U. S. NUCLEAR REGULATORY COMMISSION

Report No. 50-341/87049(DRP)

Facility Name: Fermi 2

Areas Inspected: Special safety inspection of the events that led to the loss of essential bus 72 CF on September 8, 1987, the evaluation by the licensee of the event, and the design basis for bus 72 CF.

Fig. 1

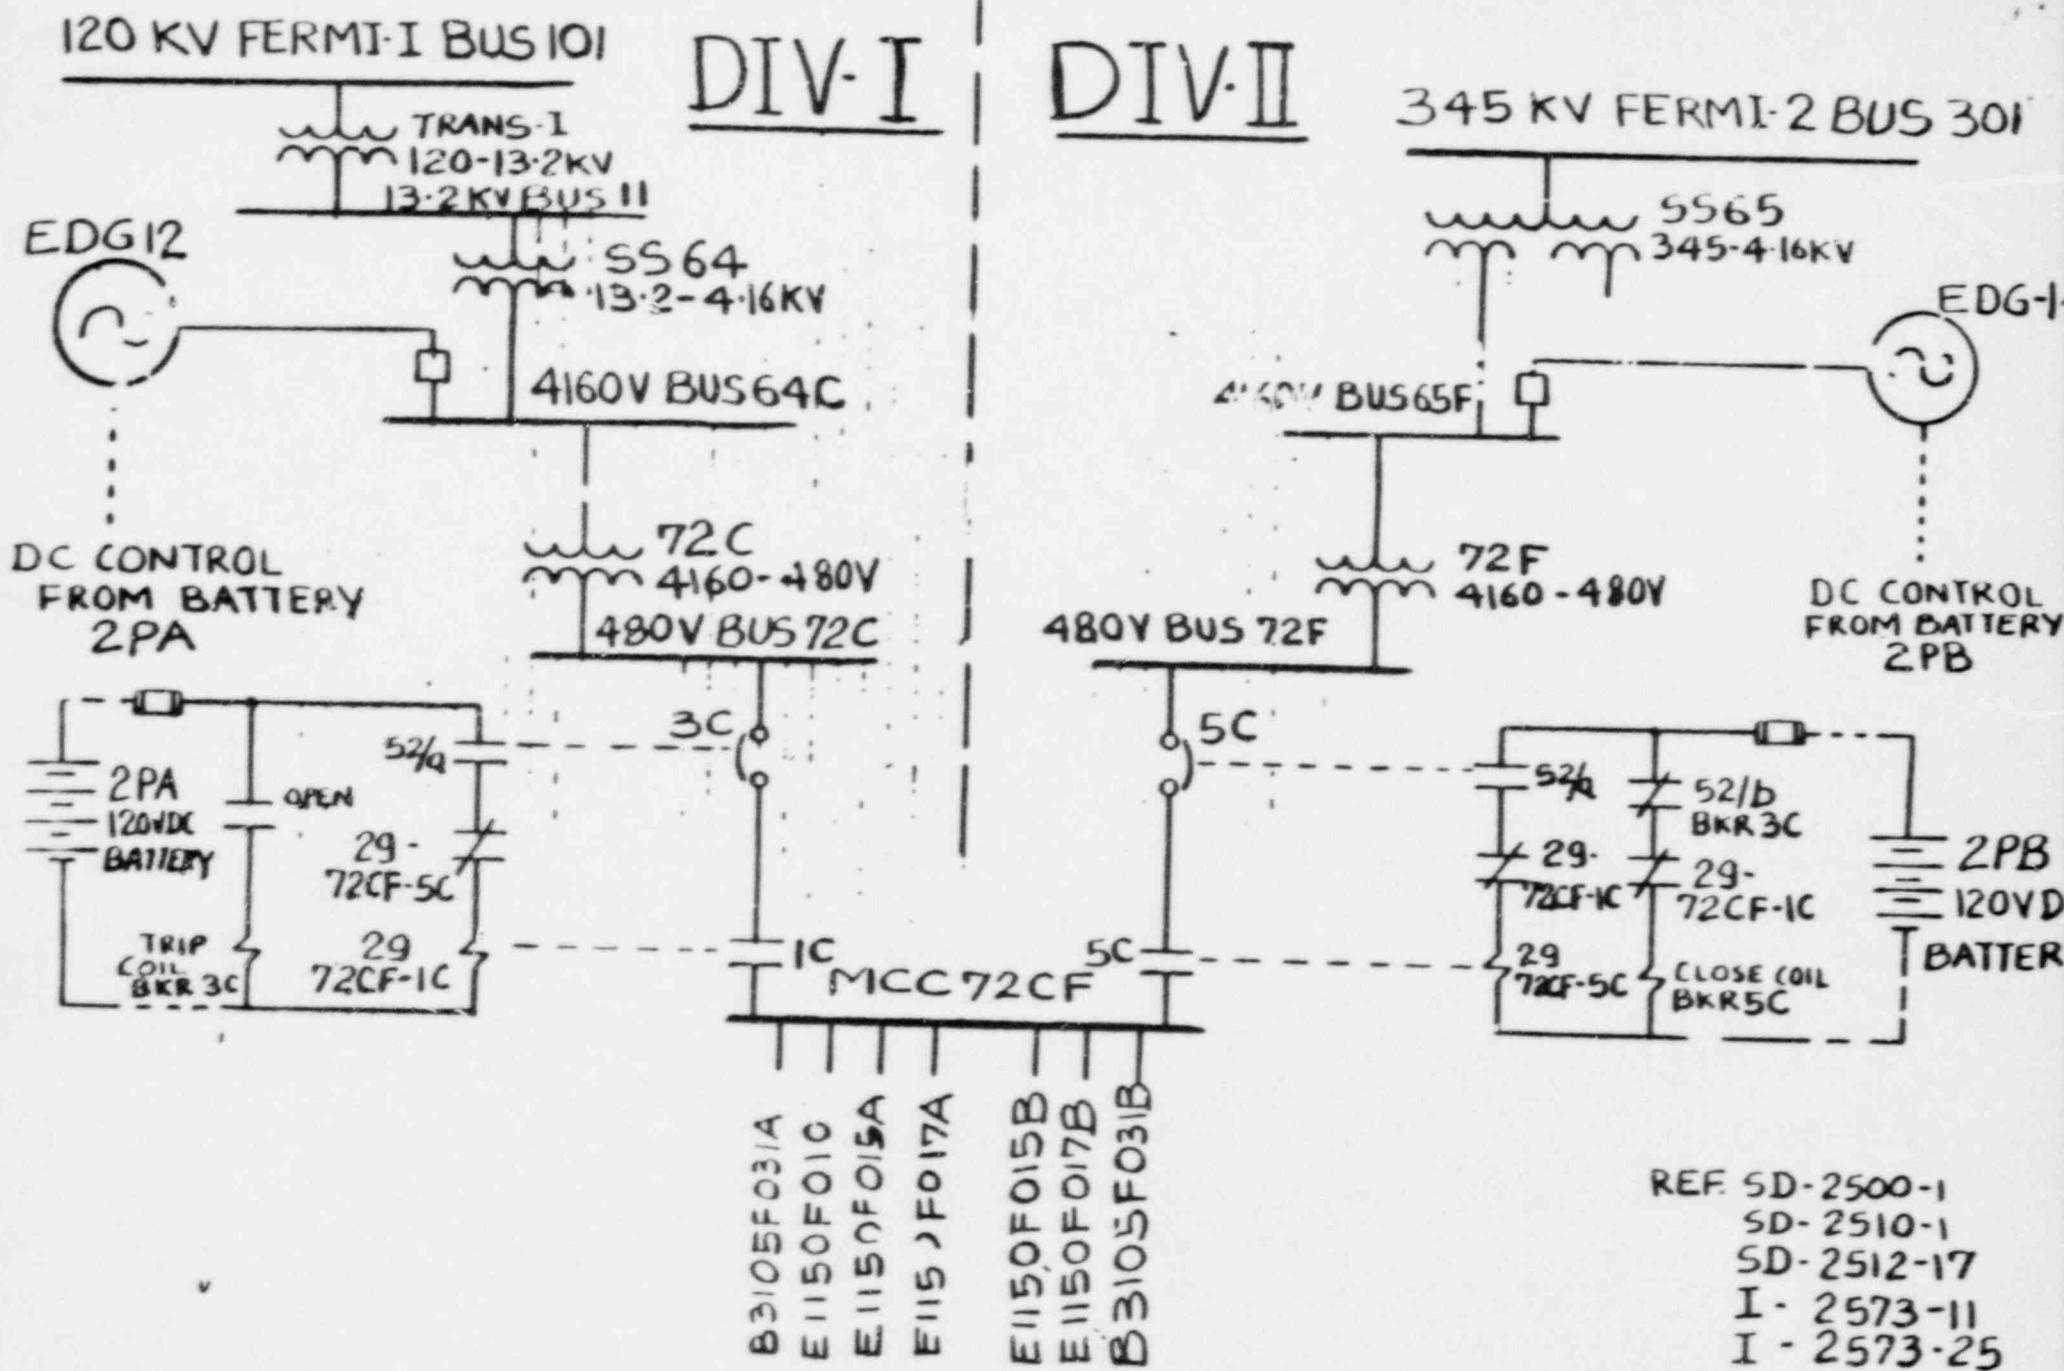
Normally, the swing bus was powered from Division 1 and upon loss of power the electrical feed to Division 2 would close providing power to the swing bus. The manner in which this power throw over logic was constructed is shown in Figure 1. For the Division 1 power feed, there was a breaker, 3C, and a contact, 1C, which must be closed. For the Division 2 power feed there was a breaker, 5C, and a contact, 5C, which must be closed. When breaker 3C opened and contact 1C opened, the closing coil for breaker 5C was energized, closing breaker 5C. Once breaker 5C was closed, the relay to contact 5C was energized, closing contact 5C. With the 5C breaker and contact closed, bus 72CF would be powered from Division 2. Power for the trip coil, for breaker 3C, and for contact 1C's relay was provided from Division 1 battery 2PA via 2PA2-14 position 2. Power for the trip coil, for breaker 5C, and for contact 5C's relay was provided from Division 2 battery 2PB.

When the switch at 2PA2-14 position 2 was opened, the Division 1 power to swing bus 72CF was lost and the automatic power feed transfer to the Division 2 power source did not occur. Opening 2PA2-14 position 2 caused a loss of power to the 1C relay deenergizing and opening the 1C contact. With the 1C contact open, the Division 1 electrical feed to bus 72CF was interrupted. Also, when 2PA2-14 position 2 was opened, power to breaker 3C's trip coil was lost. Without a powered trip coil, breaker 3C did not open. The 72CF automatic transfer to Division 2 only occurs when breaker 3C and contact 1C are open. Therefore, the automatic transfer did not occur and bus 72CF deenergized.

UFSAR subsection 8.3.1.1.4, "Engineering Safety Feature Bus Interconnections," discusses the automatic throwover function of bus 72CF, and states this automatic throwover is provided with positive interlocks, breakers, and series contractors to satisfy the "no single failure" criterion. From July 15, 1985 to October 6, 1987, the licensee's design of bus 72CF as documented on Drawing No. 617212573-11, Rev. L, did not meet the "no single failure" criterion described in the UFSAR in that a loss of Division 1 of the direct current system prevented the automatic throwover function. This matter is considered a violation of 10 CFR 50, Appendix B, Criterion III (341/87049-01).

Engineering personnel redesigned the swing bus electrical circuitry to conform to the appropriate regulatory requirements. An NRC Region III inspector and two representatives from the Electrical Systems Branch of NRR reviewed the new design and determined it to be acceptable. The new design was implemented under engineering design package 7906 prior to the licensee starting up from the maintenance outage which they had been in when the design deficiency was discovered. The NRC technical implementation review will be performed as indicated in Inspection Report No. 50-341/87042 by an electrical inspector during a future inspection. The resident inspectors attended operator training on the new swing bus design and considered the training acceptable.
